**Review of Comments Submitted to SECO on
Chapter 11, 2015 IRC & 2015 IECC during July 4-August 4, 2014 Period
ATTACHMENT C
Analysis of Proposed Amendments**

This attachment contains the stringency analysis of the proposed amendments to the 2015 IRC or the 2015 IECC energy efficiency provisions for residential buildings¹, in comparison to the Texas Building Energy Performance Standards (TBEPS), which are based on Chapter 11 of the 2009 IRC and Chapter 4 of the 2009 IECC. Each analysis was performed using a base-case single-family house that complies with Chapter 11 of the 2015 IRC and Chapter 4[RE] of the 2015 IECC with the proposed amendment vs. a TBEPS code-compliant base-case house. The analysis was performed for each of the proposed amendments separately and therefore does not represent the impact of implementing combinations of the proposed amendments. A complete description of the amendments are available on Pgs. C.15-C.35 of this attachment. Details of this analysis are provided in a separate report².

Figure C-1: Comparing the Annual Energy Consumption of TBEPS and 2015 IECC w/ Amendments Compliant Standard Reference Design House for a Typical House in Texas

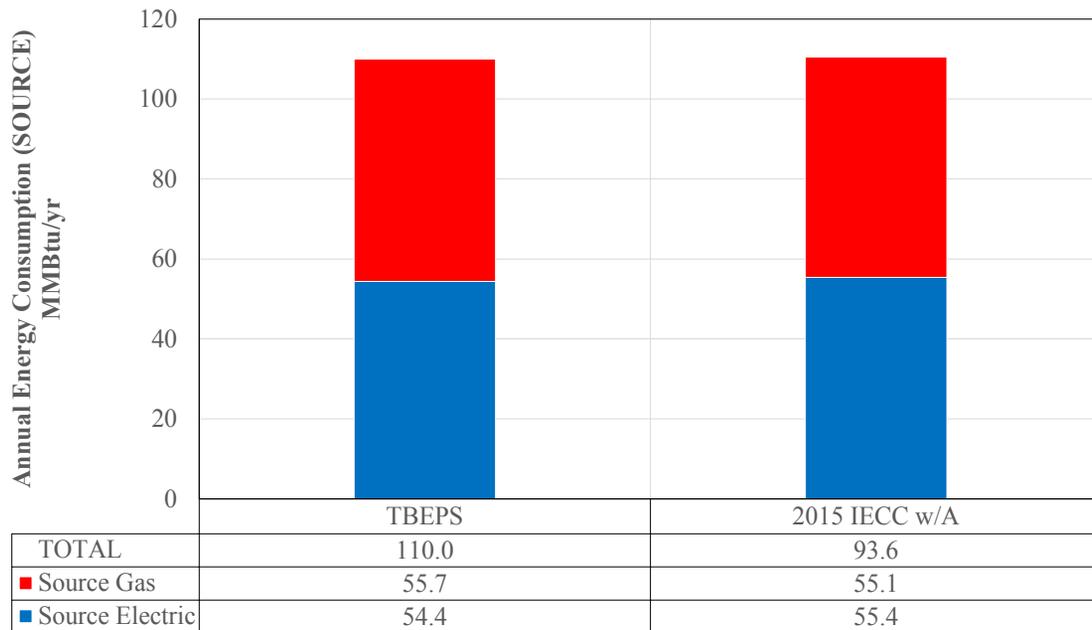
This analysis was performed to evaluate the proposed amendment to modify Table R405.5.2 (1), 2015 IECC (Table N1105.5.2 (1), 2015 IRC) by fixing the window-to-floor-area-ratio of the Standard Reference Design house at 15% in order to get credit for the energy saved in the Proposed Design house for various window sizes.

For this analysis, the window-to-wall-area-ratio of a Proposed Design house was varied for three different house sizes. Respective energy consumption of the corresponding Standard Reference house designed in accordance with TBEPS and the 2015 IECC with the WFAR fixed at 15% was evaluated.

Figure C-1 presents the annual source energy consumption of a house with typical dimensions in Texas⁴ for TBEPS compliant base-case and the 2015 compliant test-case with the WFAR fixed at 15%. The typical house in Texas is single-storied with a conditioned floor area of 2,398 ft² and a window-to-floor area ratio of 11.9%. For a typical house in Texas, the annual source energy consumption of the 2015 IECC compliant test case with the proposed amendments was lower than the corresponding source energy consumption of the TBEPS compliant base-case. Table C-6 presents the annual source energy consumption of the TBEPS compliant base-cases, with various window-to-wall-area-ratios (WWAR), and the 2015 IECC compliant test-cases with the WFAR fixed at 15%. In certain cases the 2015 IECC compliant test-cases with the proposed amendment consume more energy than the TBEPS compliant base-cases.

For a typical house in Texas, the proposed amendment meets the TBEPS. For certain other test cases as seen in Table C-6, the proposed amendment is less stringent than the corresponding TBEPS compliant base-case.
